Salman Adnan Ltd. Azim & Son Ltd.

35-B/1, Indira Road, Dhaka-1215
(23.757772N, 90.385554E)

21st March 2015

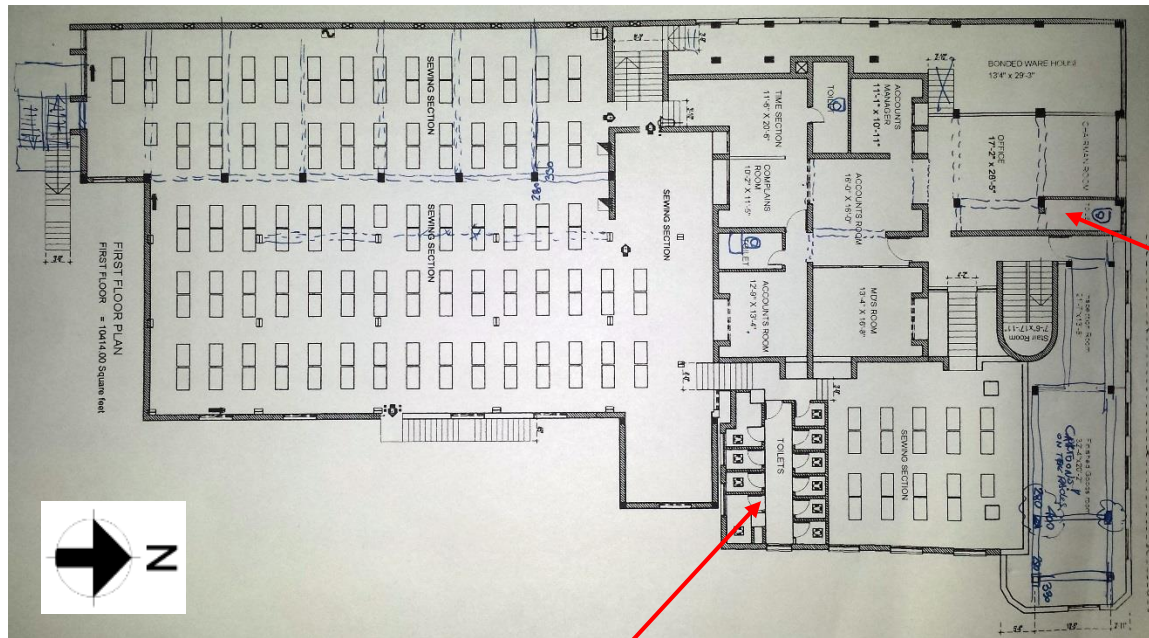
Heavy loads on floors

Build-up sin the toilet
on 1st floor (90mm)

Build-ups in the toilets zones on 1st floor (70mm)

Item No.	Observation	Recommended Action Plan	Recommended Timeline
1	Buildings 1A, 1B and 1C - Heavy loads on floors	Building Engineer to review design, loads and slab stresses in all buildings.	6-weeks
2	Buildings 1A, 1B and 1C - Heavy loads on floors	Produce and actively manage a loading plan for all floor plates within the factory, giving consideration to floor capacity and column capacity.	6-months
3	All buildings - discrepancies on Permit drawings	Building Engineer to survey all buildings for correct structural layout and dimensions.	6-weeks
4	All buildings - discrepancies on Permit drawings	Building Engineer to produce accurate as-built drawings for all buildings.	6-months

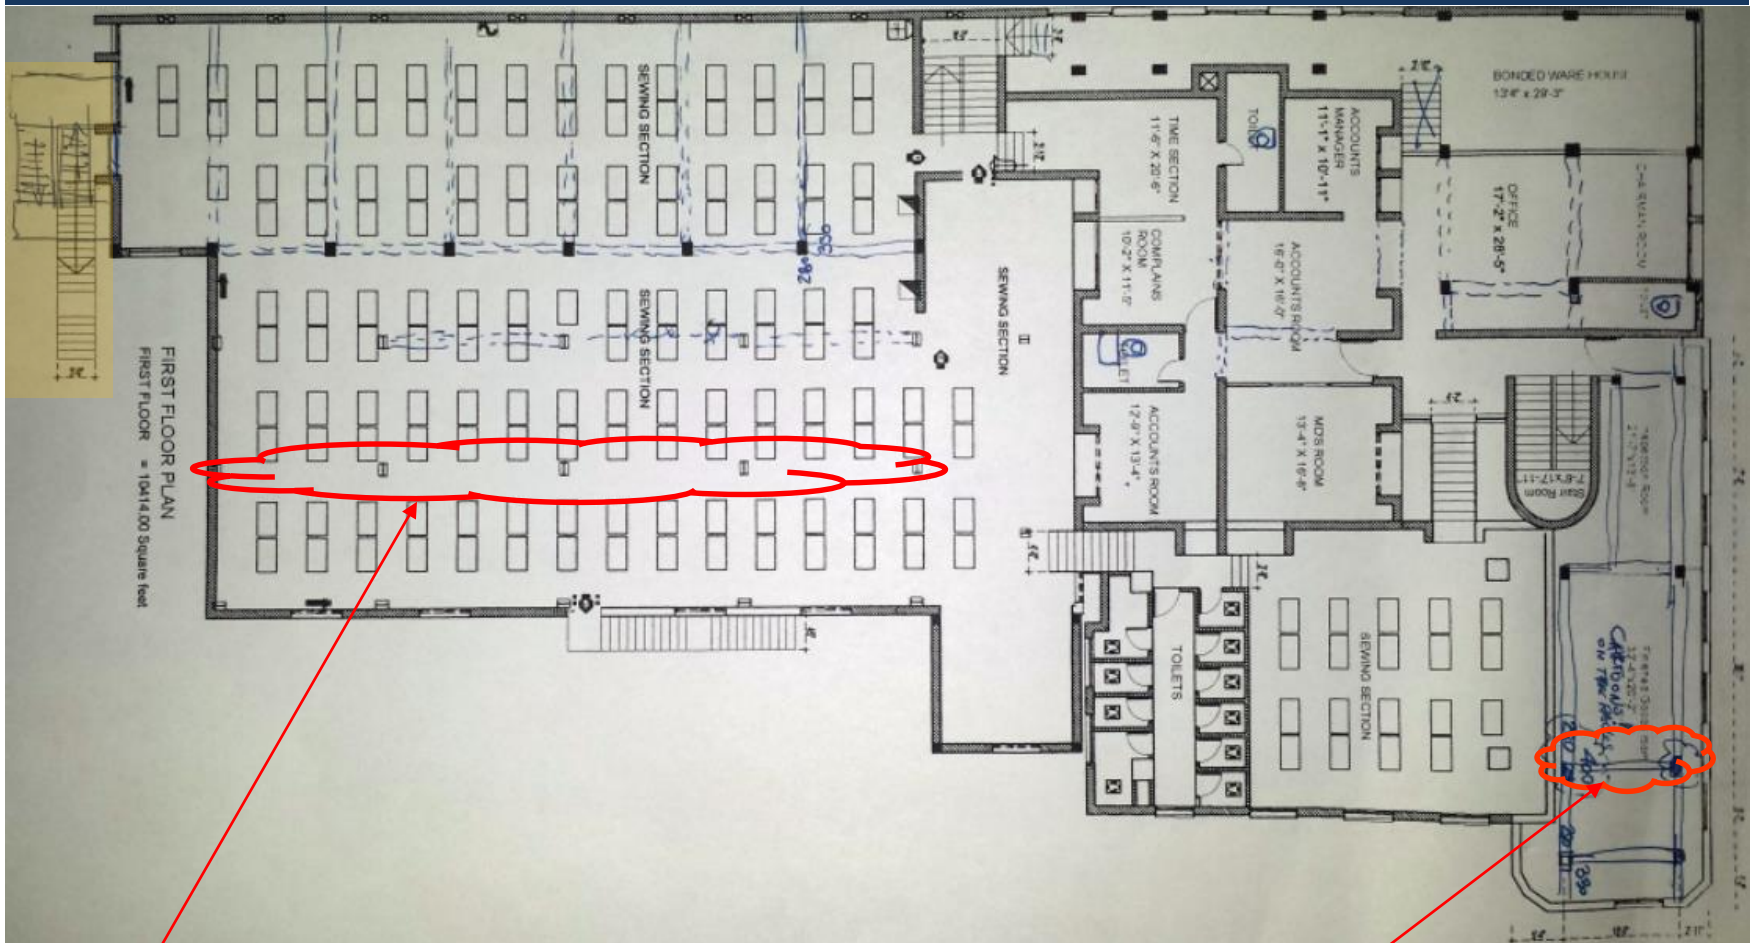
All buildings - discrepancies on Permit drawings

Staircase

Columns not present on site

Missing columns on the plans

Differences between architectural “as-built” drawings and on site observation.
